**SUBSURFACE WASTEWATER DISPOSAL SYSTEM APPLICATION**

Town Or Plantation: AUGUSTA  
 Street: EIGHT ROD ROAD  
 Subdivision Lot #: \_\_\_\_\_  
**PROPERTY OWNERS NAME**  
 Last: BASTEY First: JOHN  
 Applicant Name: \_\_\_\_\_  
 Mailing Address of Owner/Applicant (If Different): RFD 3 BOX 967A EIGHT ROD ROAD AUGUSTA, ME. 04330

Re: Subsurface Wastewater Disposal System, Eight Rod Road, Augusta

## SUBSURFACE WASTEWATER DISPOSAL PLAN

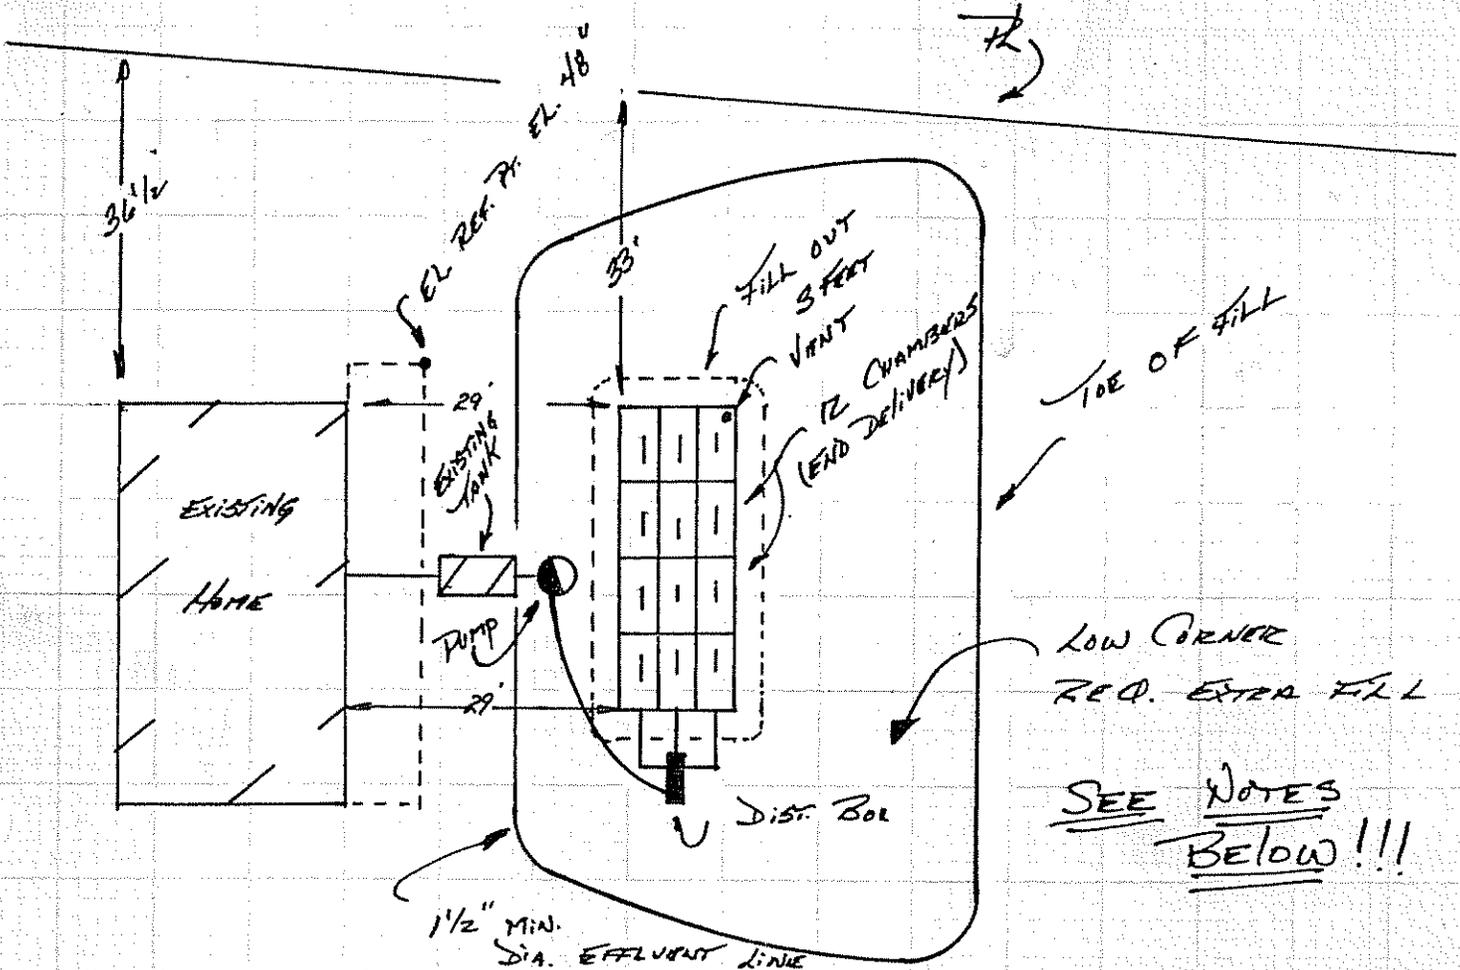
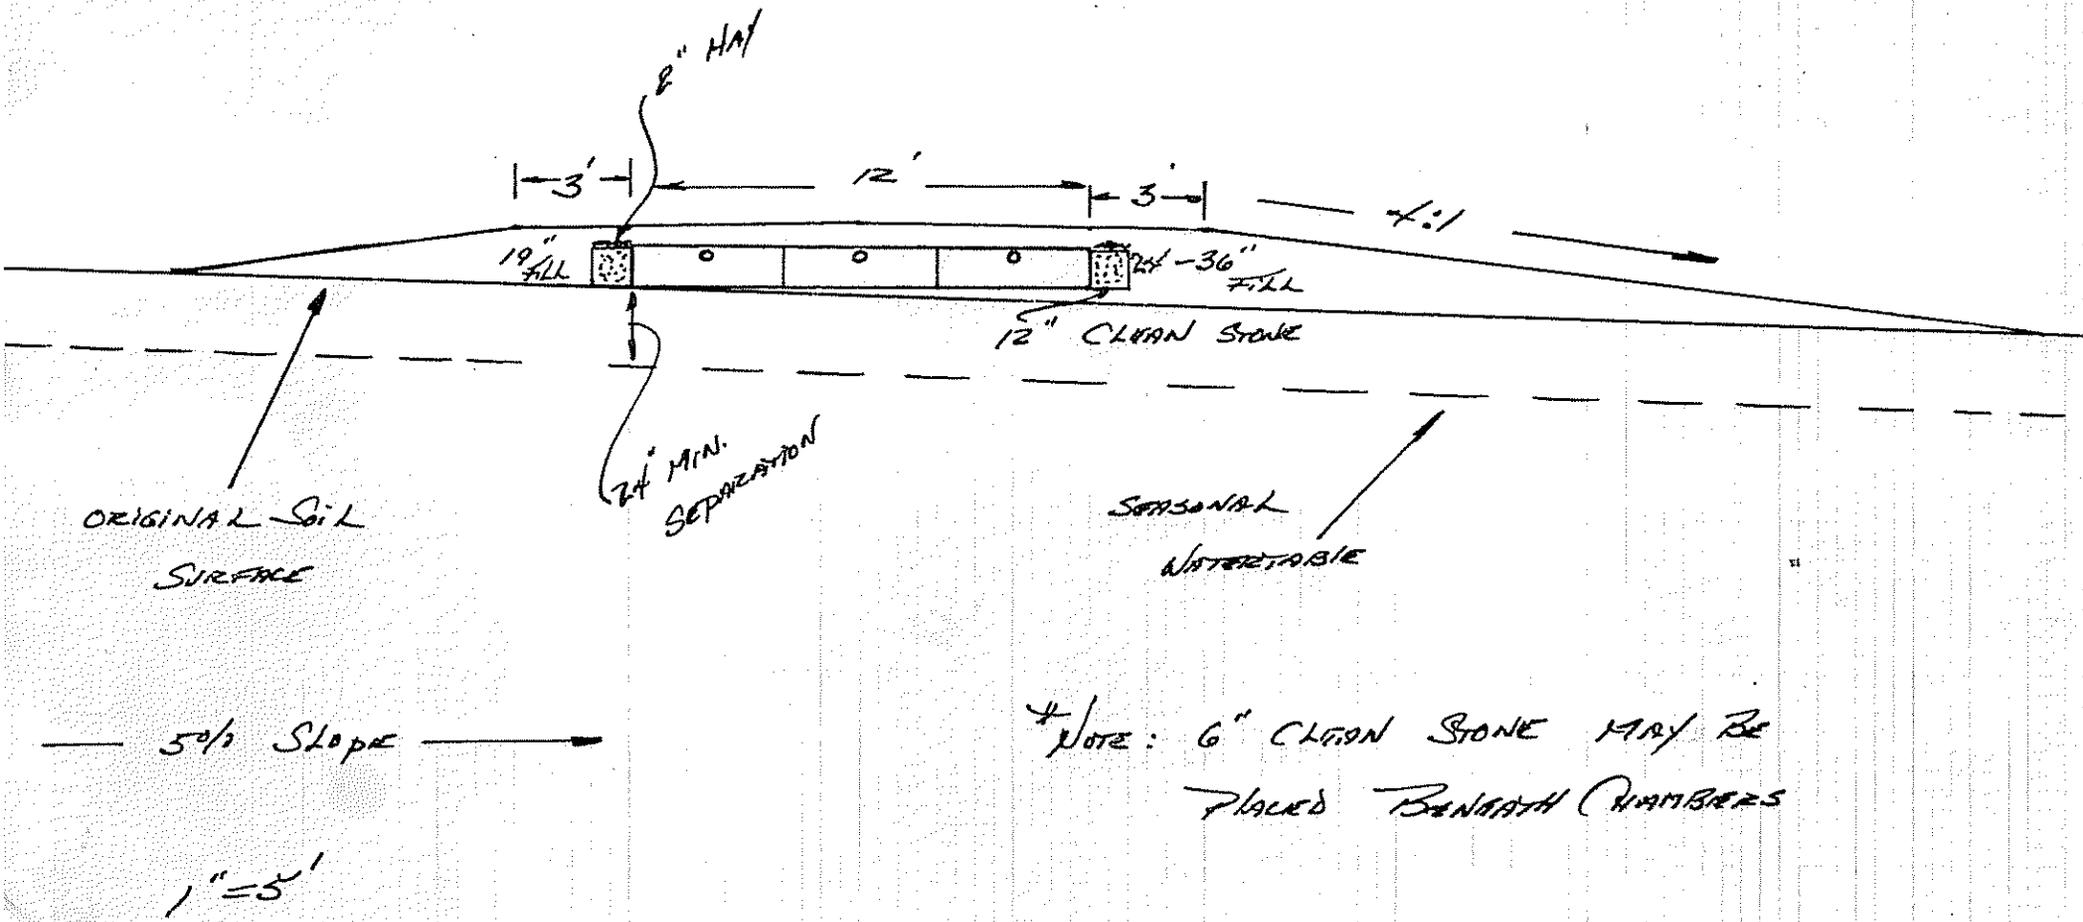
LOW CORNER  
REQ. EXTRA FILL  
SEE NOTES  
BELOW!!!

- REMOVE ALL TRACES OF EXISTING BED + CONTAMINATED SOIL. REPLACE WITH SANDY FILL SIMILAR TO EXISTING SOILS - COMPACT TO PREVENT SETTLEMENT.
- CHECK EXISTING TANK AND SEAL TO INSURE NO INFILTRATION OF SEASONAL GROUNDWATER. CHECK ROOF DRAINAGE AS WELL.
- GRADE TO DRAIN - DO NOT ALLOW SURFACE WATER TO POOL ON OR ADJACENT TO CHAMBERS.
- STABILIZE SYSTEM BY SEEDS + MULCH.

Our recommendation is to remove the chambers and fill material. New fill should be brought in, which is at least as coarse textured as the original soil, and the chambers placed on this fill at the elevation specified on Mr. Beers original plan.

## SUBSURFACE WASTEWATER DISPOSAL PLAN

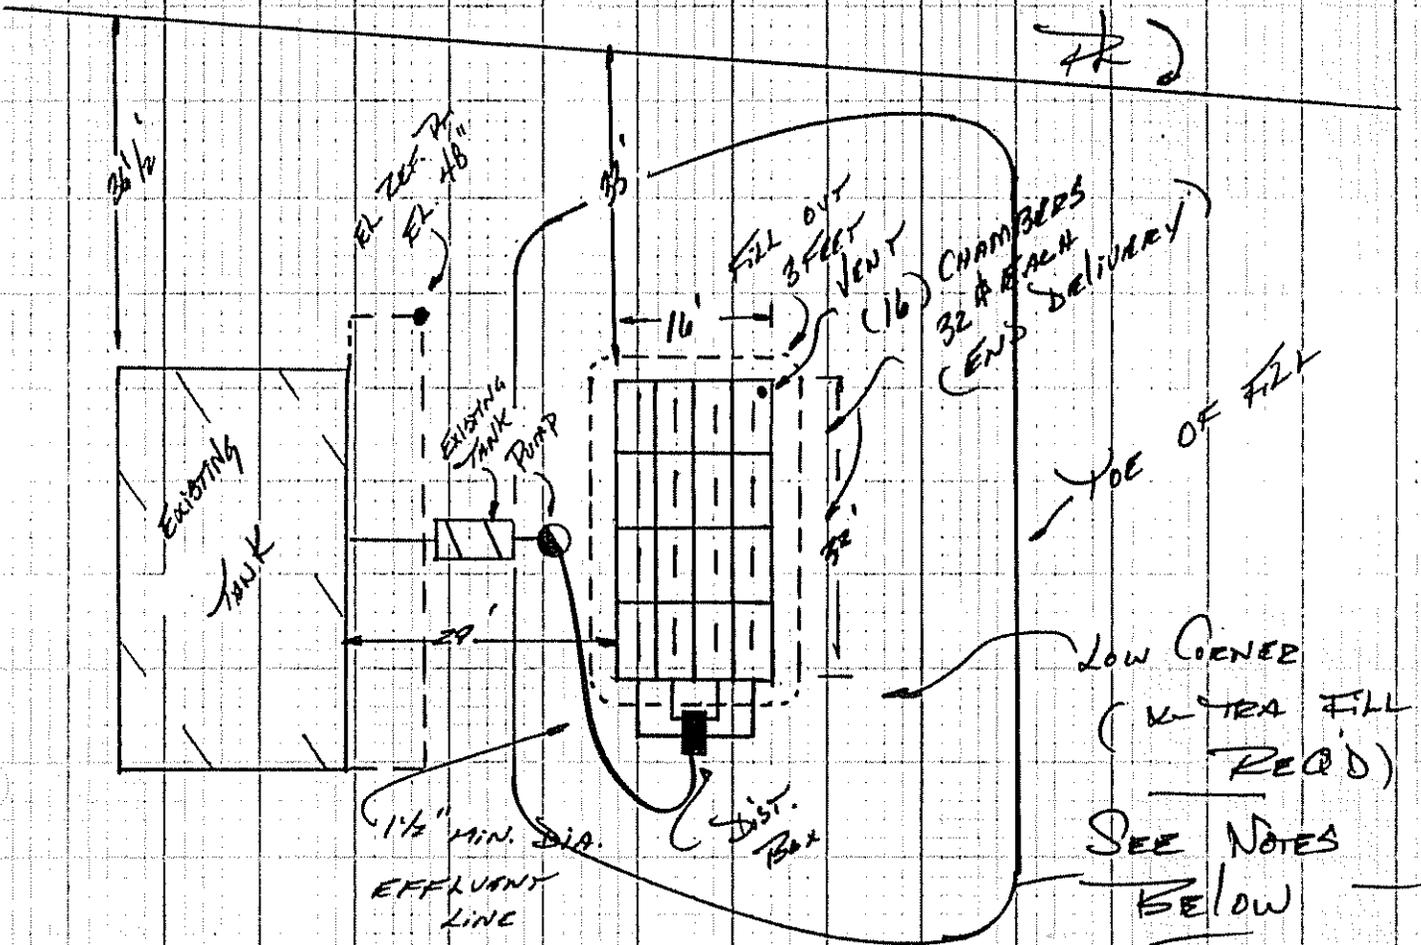
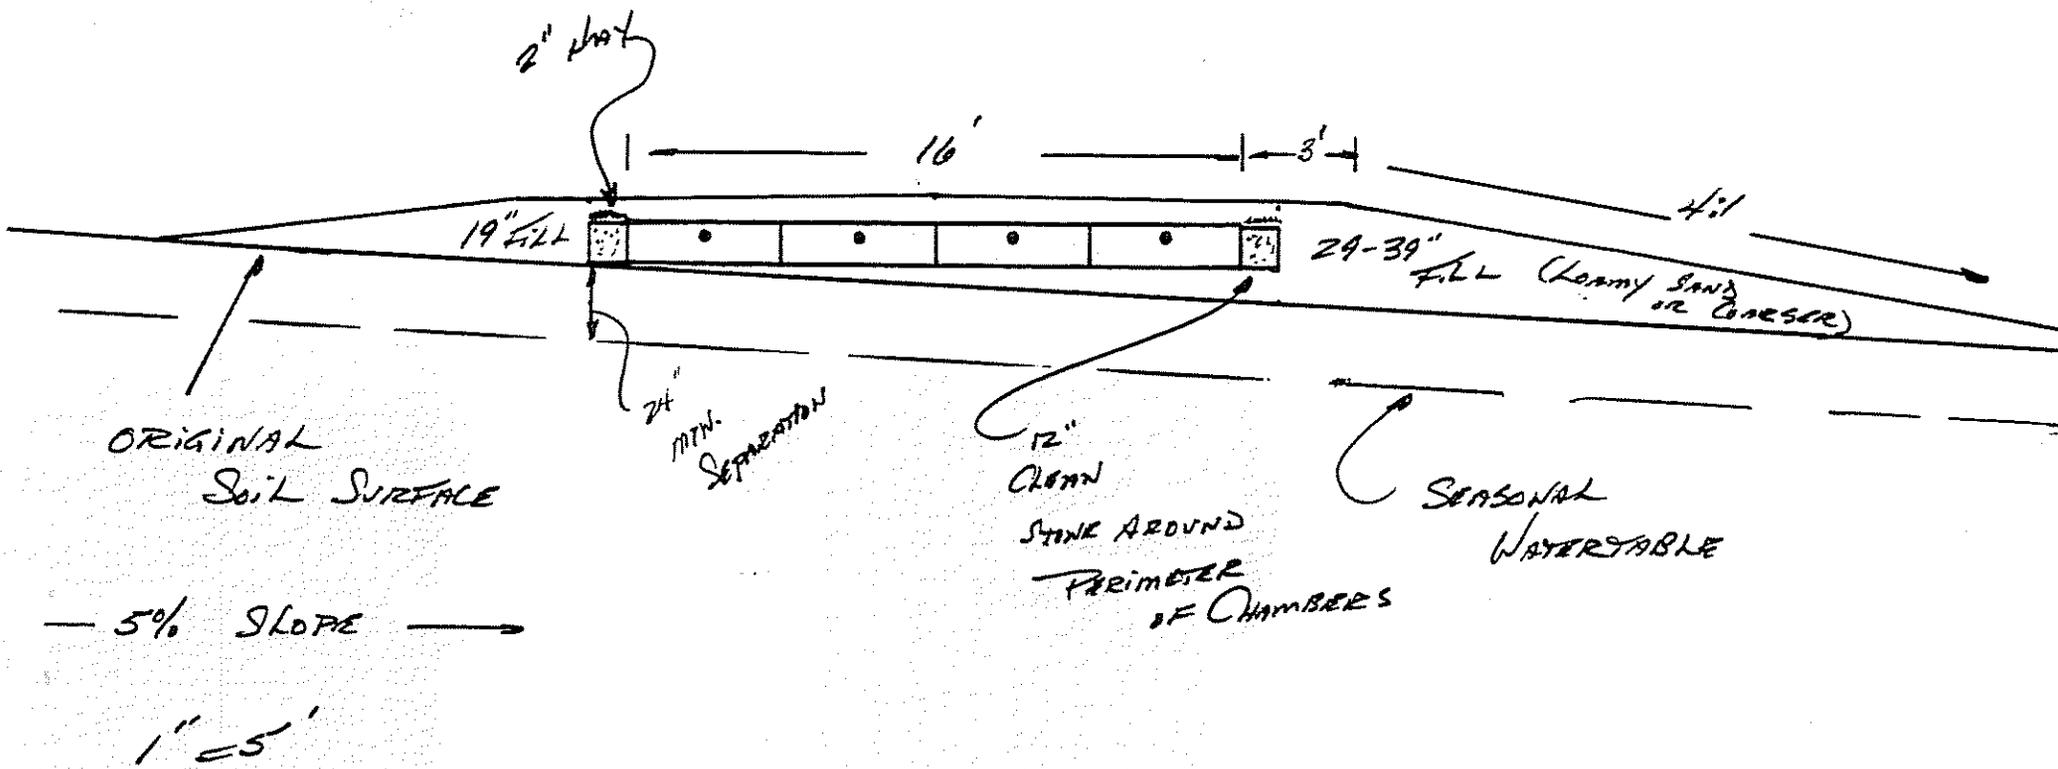
THIS A REVISED HHE-200 FORM TO EXPAND SYSTEM DESIGNED ON 7/28/85 - ADD 4 CHAMBERS TO EXISTING SYSTEM OF 12 FOR TOTAL OF 16. REMOVE EXISTING FILL AROUND SIDES (3) OF EXISTING CLUSTER & REPLACE W/ COARSE FILL FOR GREATER STORAGE AND INFILTRATIVE CAPACITY TO ACCOMMODATE EXISTING FLOWS. STABILIZE BY SEEDS & MULCH. OTHERWISE INSTALL AS RECOMMENDED 7/28/85
